Mountain Laurel Estates Subdivision

**EASTERN CONNECTICUT
ENVIRONMENTAL REVIEW
TEAM REPORT**

Mountain Laurel Estates Subdivision
North Stonington, Connecticut

Review Date: August 16, 1990
Report Date: October 1990

LOT LAYOUT MAP

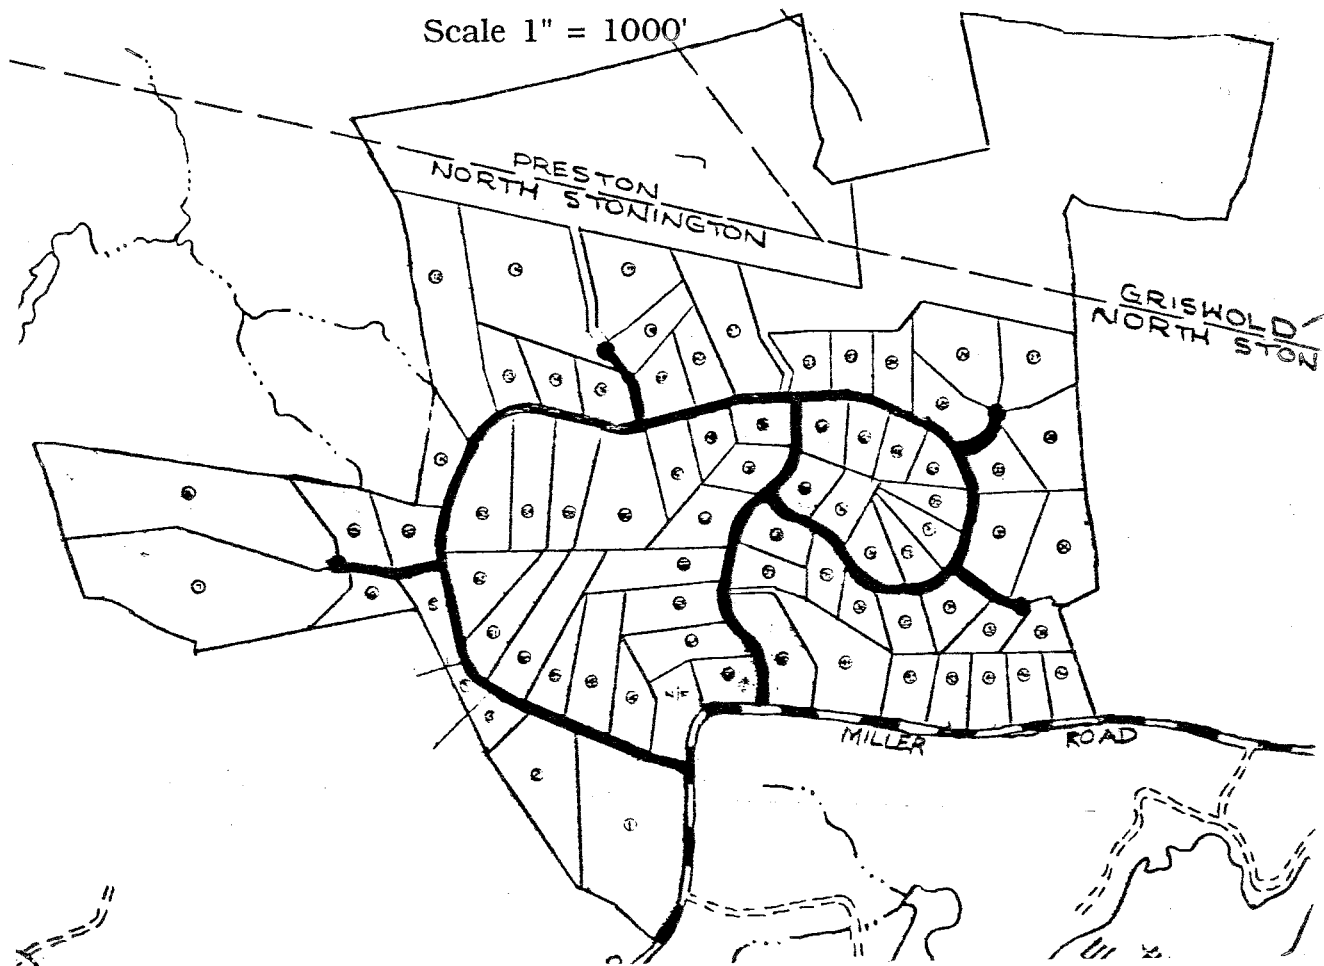
The proposed project will consist of 75 building lots on about 310 acres in northern North Stonington. No plans for the development of the land area that lies within the towns of Preston and Griswold were shown on the subdivision plan. It should be pointed out that in general hostile surface and subsurface conditions characterizes the land in Preston and Griswold. Steep slopes, shallow to bedrock soils and wetlands are widespread and will be major hindrances with regard to the details of siting septic systems and access.

According to present plans, the 75 building lots which range in size from 1.8 acres to about 17 acres would be served by +2 miles of paved road that includes four ±600 foot long cul-de-sacs and, in North Stonington, about 8 acres of open space. The subdivision plan indicates that the 67 acres in the town of Griswold would also be designated as open space. The main access road will cross approximately 660 feet of wetlands. In some places, road grading or the access road to the proposed open space will impact wetlands. Lots 1, 40, and 49-53 contain moderate amounts (>40%) of regulated wetland soils. Buildings, septic systems and access drives on these lots may be within the 100 foot wetland setback requirement imposed by the town. Each lot in the proposed subdivision would be served by an individual on-site septic system and well.

- 3) In instances where the crossing of watercourses is necessary, (cul-de-sac to lots 7 & 8, roadway between lots 11 & 53), a box or arch culvert is recommended rather than the proposed pipe culvert crossings. The arch or box culverts, while requiring a comparable degree of construction disturbance, will provide a more open corridor for wildlife and maintain a greater amount of wetlands and habitat area.

WATERSHED BOUNDARY

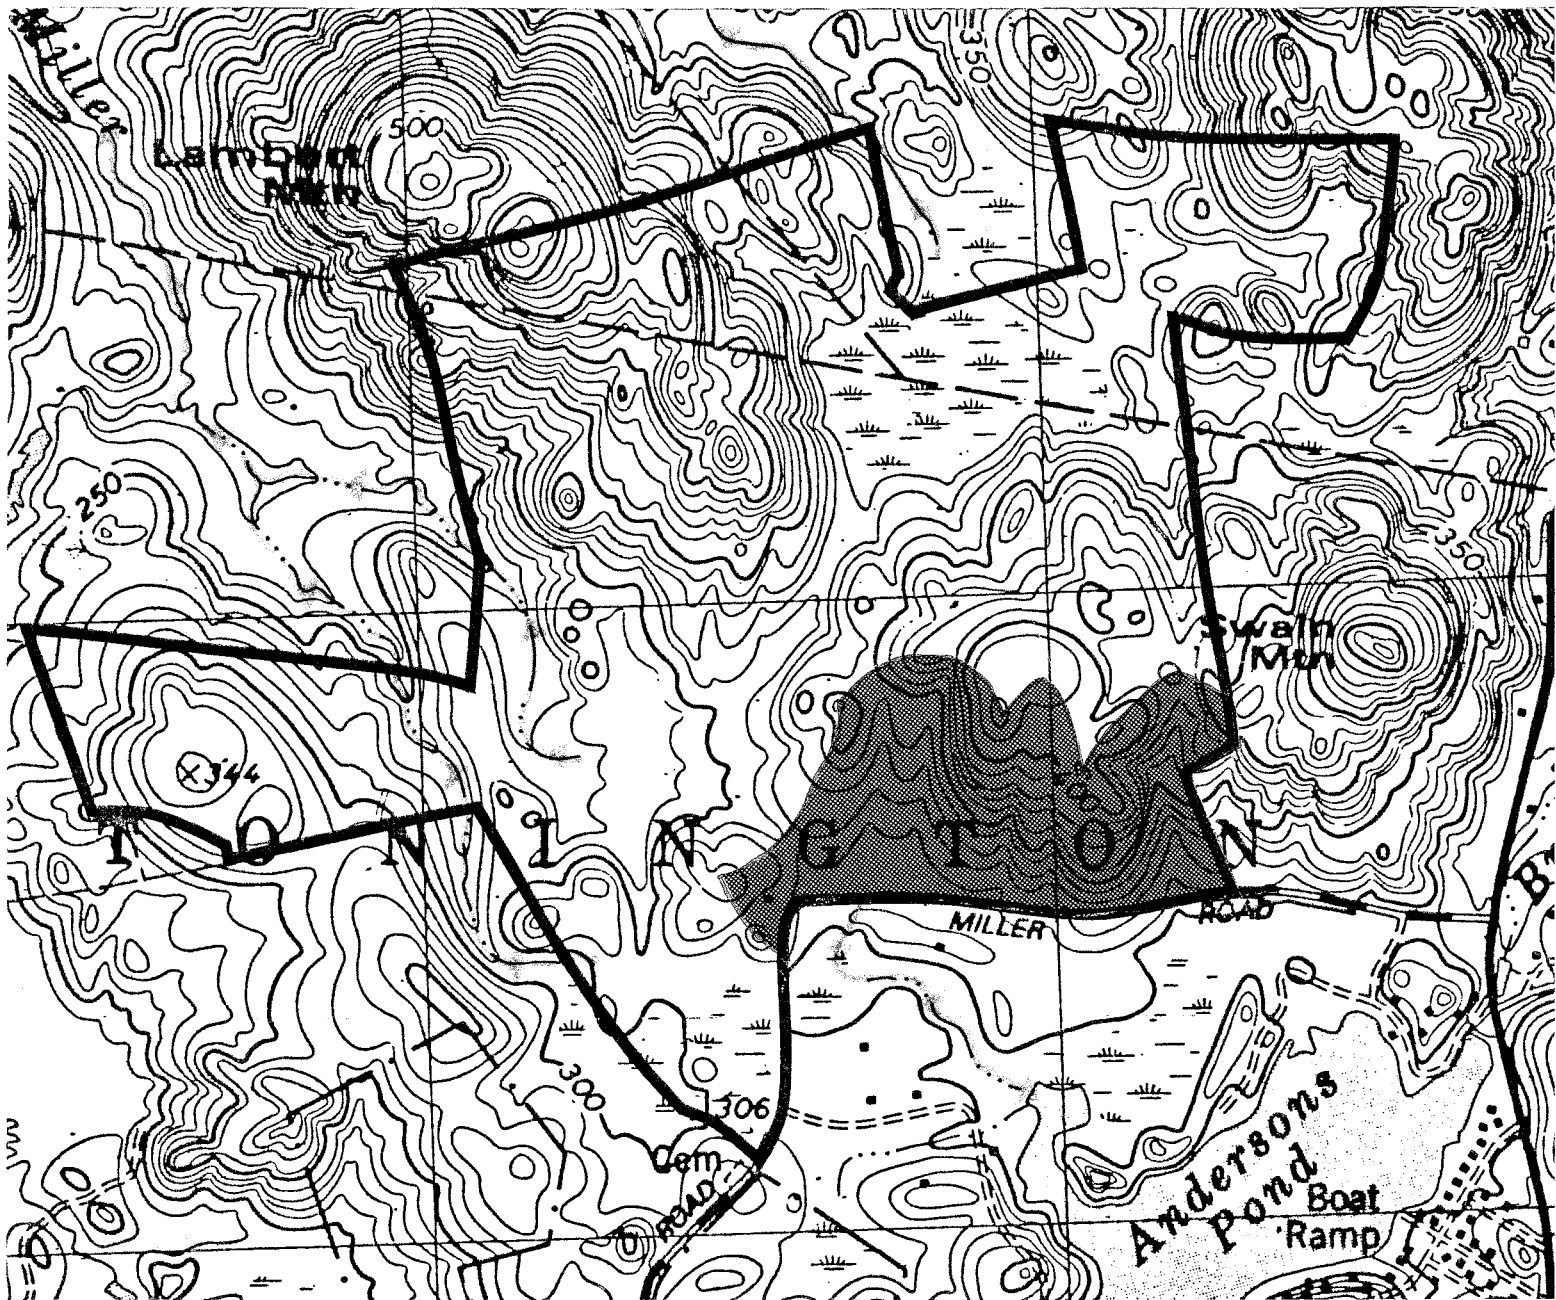
Approximately 56 acres located in the southern parts of the site drains southward to Andersons Pond. The remainder of the site, about 353 acres drains to three unnamed northwesterly flowing streamcourses that are tributary to Miller Brook. Two of the three streamcourses mentioned in the preceding sentence occur in the western parts of the site, while the third is the outlet stream for the wetlands located in the northern parts of the property. Miller Brook, from its point of outflow at Lewis Pond (northwest of the site in Preston) drains an area of 8.23 square miles or about 5,300 acres.

Approximately 1/3 of the proposed lots or parts thereof are located in the drainage area that flows to Andersons Pond. The remaining ± 50 lots lie within the Miller Brook drainage area.

It is estimated that about 660 linear feet of the new subdivision road (not including potential driveways and open space access road) will need to cross regulated wetlands in 4 places. The proposed road layout appears to have been designed to minimize wetland impacts on the site.

It should be noted that no details for the road crossings were available to team members on the review day. Except for the most extensive wetland crossing, which is about 300 feet (near Lots 1 and 47), the remaining 3 wetland road crossings appear feasible, but only if they are properly engineered. They should be constructed adequately above the surface elevation of the wetland. This will allow for better drainage of the road and decrease the frost heaving potential. All wetland crossing construction activity should be done during the dry time of year and should include provisions for effective erosion and sediment control. Any unstable, or mucky material should be removed and replaced with a permeable road base material. The ±300 foot wetland crossing near Lots 1 and 47 will need to cross Aa soils (Adrian and Palms Mucks). Because of their mucky composition and because the water table is at or near the ground surface most of the year in this area, road construction through this area will be extremely difficult and as such should be avoided, if possible. It is suggested that an alternate road route be considered for this area. (Also see **Wetland Resource Concerns** section of this report)
